**RE: 700 MONTANO SUBDIVISION (F14-D36). DRAINAGE REPORT AND GRADING PLAN FOR PRELIMINARY PLAT, BUILDING PERMIT, AND GRADING PERMIT APPROVALS. ENGINEER'S STAMP DATED JANUARY 12, 1999.**

**RE: Drainage Report for 700 Montano Subdivision  
including the  
Grading & Drainage Plan for Javier Estates  
Tierra Est, LLC, (Stamped by Ron Bohannan, P.E. 1-12-99)**

# 700 Montano Subdivision

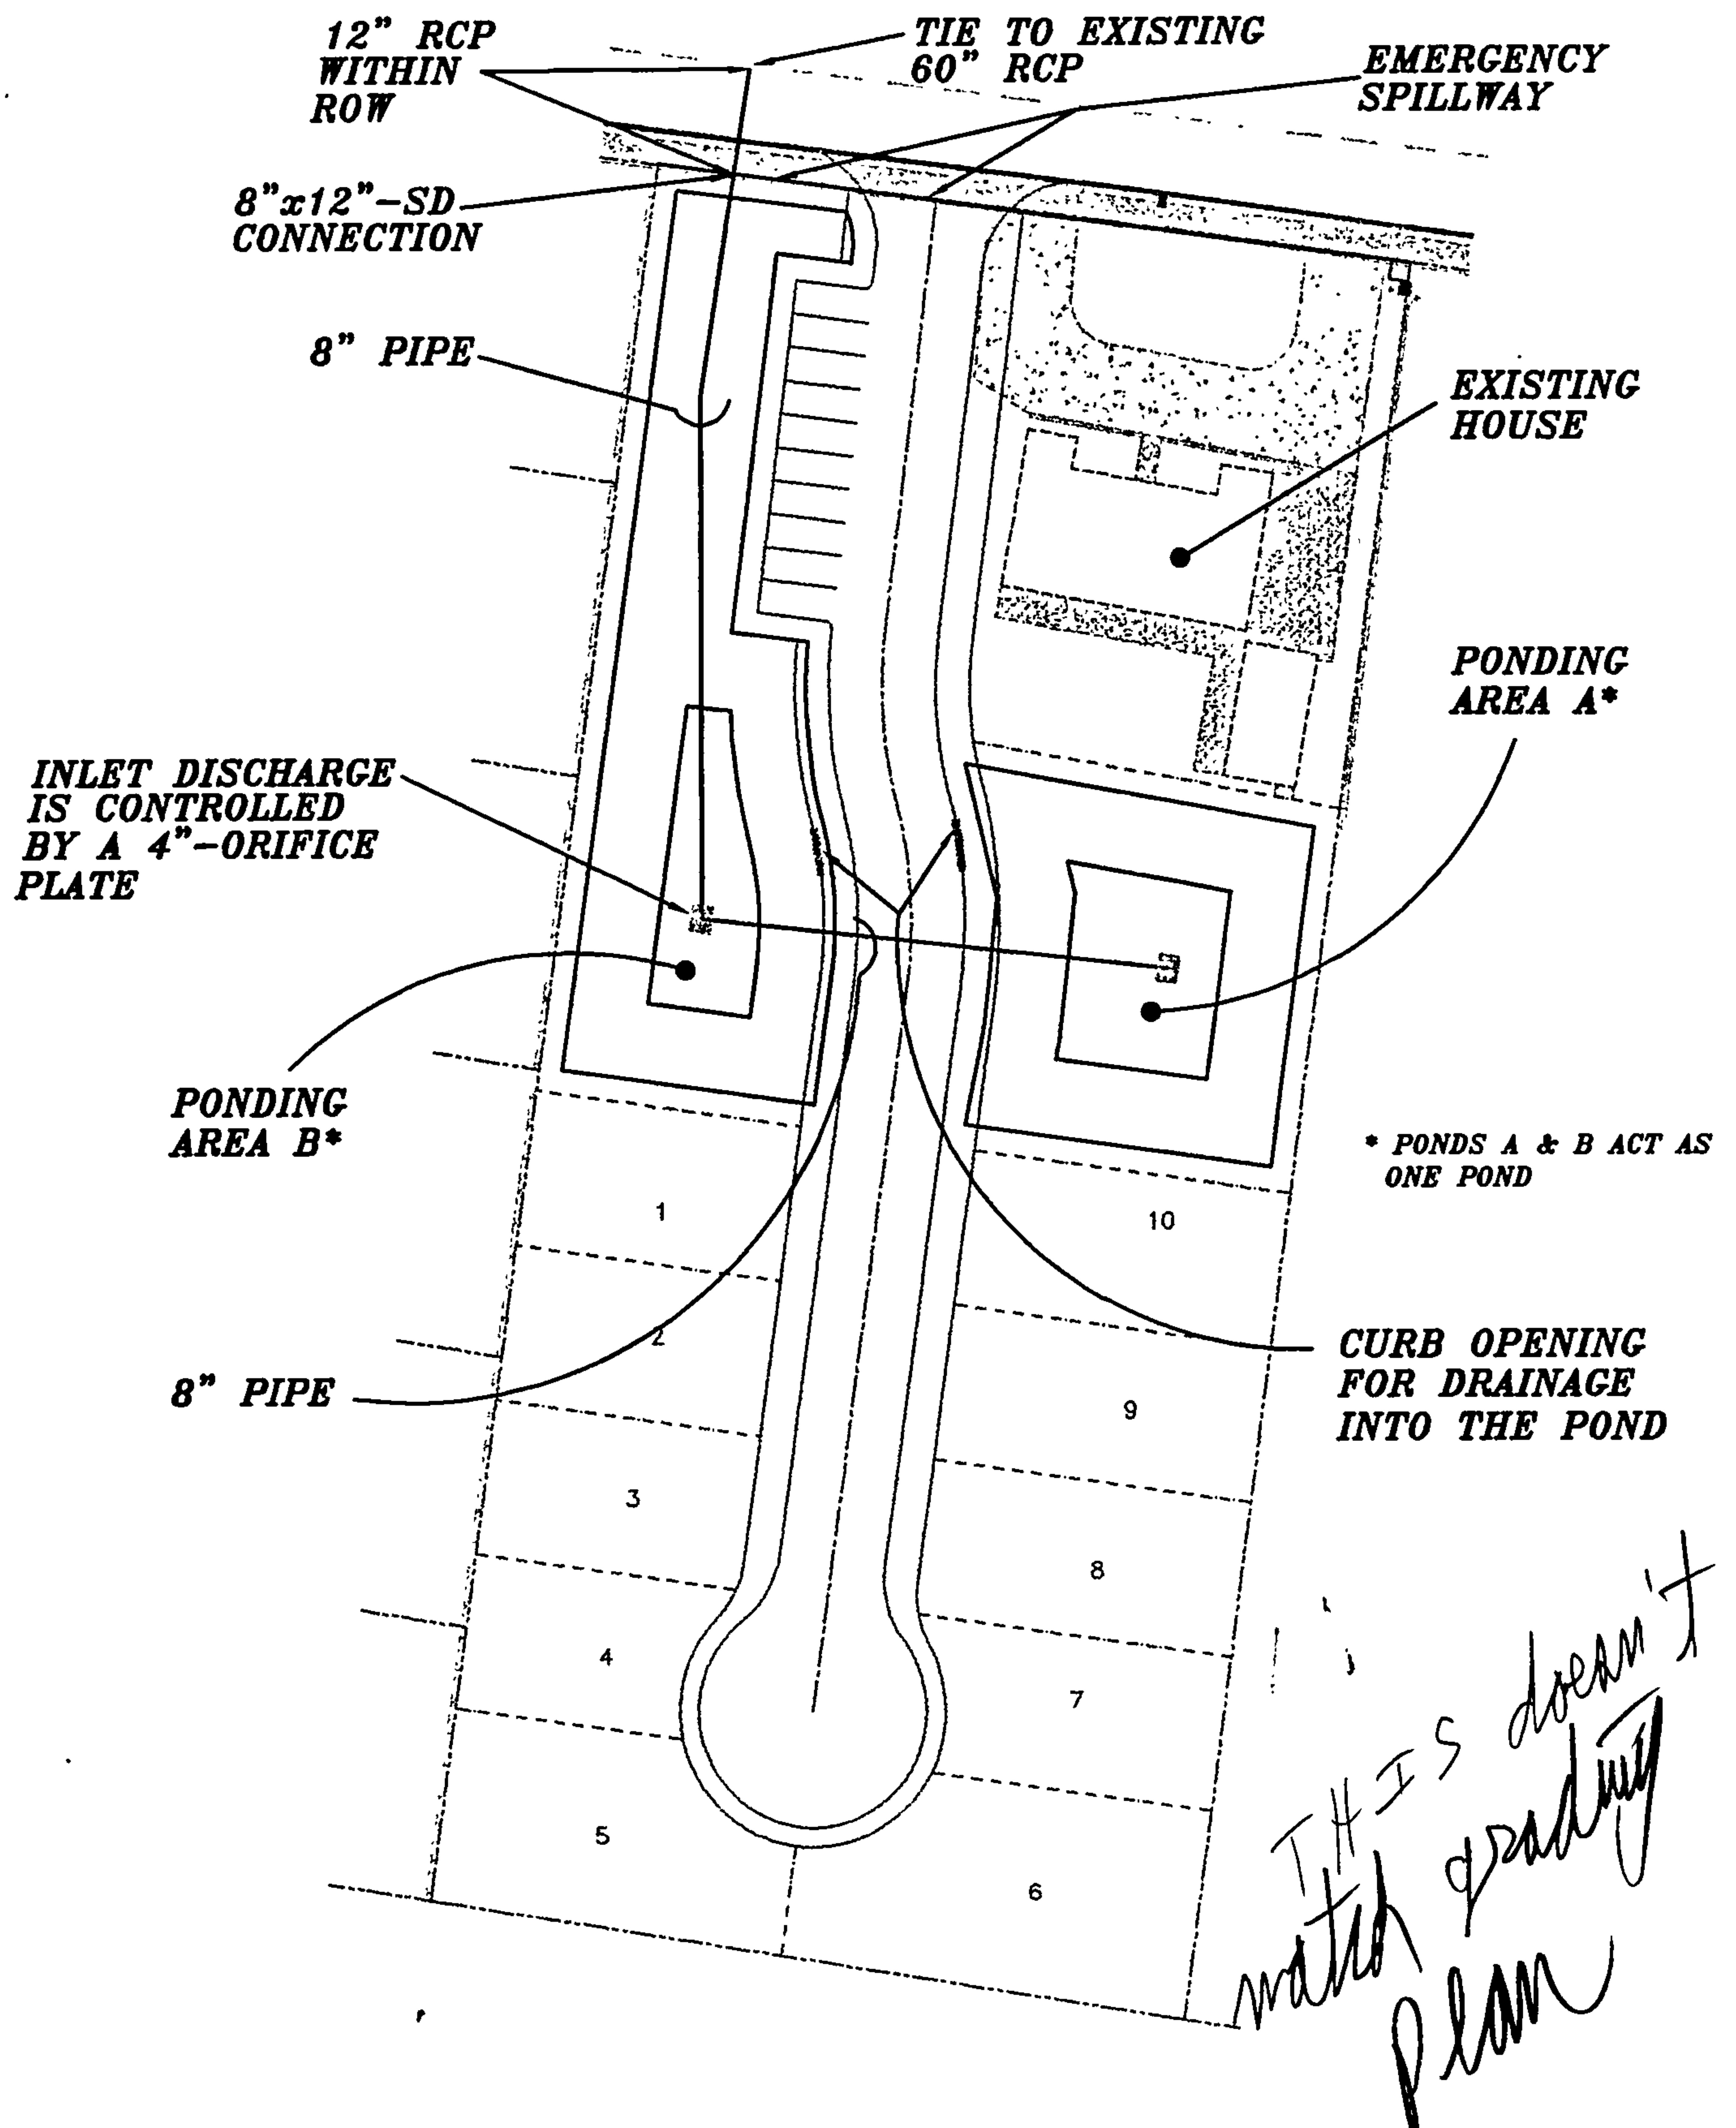
1. The Drainage Report text indicates that the project is to have two detention ponds as do some small figures in the report. The grading plan only shows 1 pond. This must be corrected.
2. The report text indicates the ponds were sized to handle the 100-yr. 10-day storm. The AHYMO model does not simulate this, nor are any calculations presented external to the model to substantiate this. (The AHYMO model was only run for a 6-hour storm.)
3. Page 13 - Pond Calculations - There are only calculations presented for 1 pond. In addition, even assuming only 1 pond as shown on the 24"X36" grading plan. There appear to be numerous errors on this pond calculation sheet as compared to the pond information shown on the grading plan. The apparent errors are as follows:
  - A. Maximum ponding depth shown on calc. sheet is listed as 1.25 . The AHYMO

reservoir routing summary indicates the maximum water surface elevation as 4972.86 and the invert of the pond is shown as 4969.9. Therefore, the maximum water depth is 2.96 feet.

Therefore, a fence is required due to the depth. That is not shown.

- B. The bottom pond elevation on the calc. sheet is shown to be 4968. That is 1.9 feet deeper than the pond as the grate elevation is shown as 4969.9. The pond volume calculations are therefore over estimated.
- C. The bottom pond area is listed as 3,646 sq ft. I measured the 4970 contour which is the lowest contour in the pond bottom and computed only 1200 sq ft. Therefore, again the pond volume calculations are over estimated.
- D. The calculation sheet has errors in the "D" column. (there appear to be some typos in the numbers listed). Is this column suppose to be the incremental depth?
- E. What is the source of the Volume formulas presented on this sheet? I am not sure that the formulas are correct?
- F. It would appear that the site design changed, and the pond calculations and AHYMO model were not revised, nor was the report text, to match the grading plan.

PLAN SHOWS  
WSE @  
4971.42
